FRAMATOME ANP

August 9, 2004
NRC:04:040

Additional Information Related to the Review of BAW-10241(P)

Attachment A

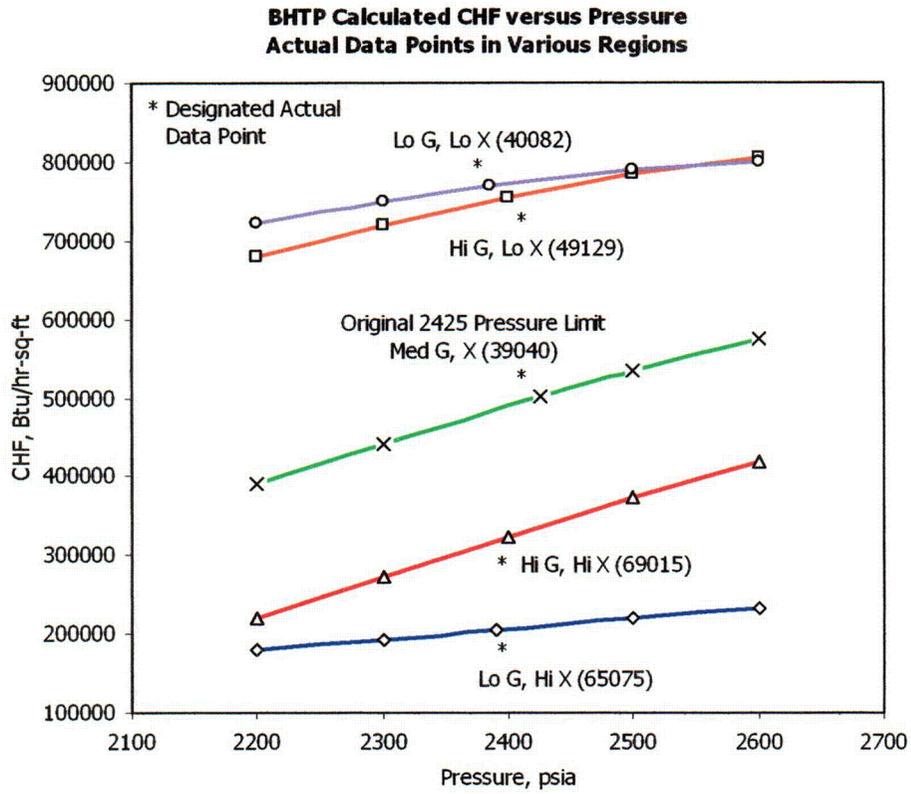
Attachment A to this letter is a plot of CHF versus system pressure from 2200 to 2600 psia. In Reference 2, a similar plot was submitted to the NRC of CHF versus system pressure from 2200 to 2500 psia. In Figure 2 of this reference, two numbers were transposed and one number was incorrectly labeled. This has been corrected on the attached plot. Since the key component of the labeling is the "Hi/Lo" designation, we view the CHF data point designation as insignificant for interpreting and applying the figures.
